BAR Meeting
January 18, 2017

ISSUE: Permit to Demolish/Capsulate and Certificate of Appropriateness for an Addition (skylights) and Alterations

LOCATION: 115 North Fairfax Street

BAR2016-00439 & 00440

Figure 5: Proposed bollard design

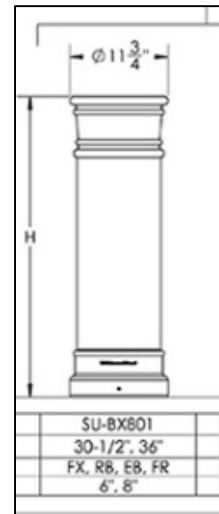
The *Design Guidelines* do not specifically address the design of bollards, but they do recommend that: “...above grade elements of a parking garage or lot such as fences, walls, gates, lights, signage and bollards and chains, should not detract from the architectural character of the surrounding buildings...” The applicant has indicated that for many years their property has been used illegally as a parking area by the public and by visitors to the adjacent bank. Efforts to stop the illegal parking have been unsuccessful, so two retractable bollards are now proposed. The black, cast aluminum bollards will measure 30” in height and 6” in diameter and can be controlled remotely by the building tenants. Although it’s unfortunate the applicant must install the bollards, staff believes that they will be minimally obtrusive and will not obscure views of the historic building or surroundings.

With the vent condition discussed above, staff recommends approval of the application.
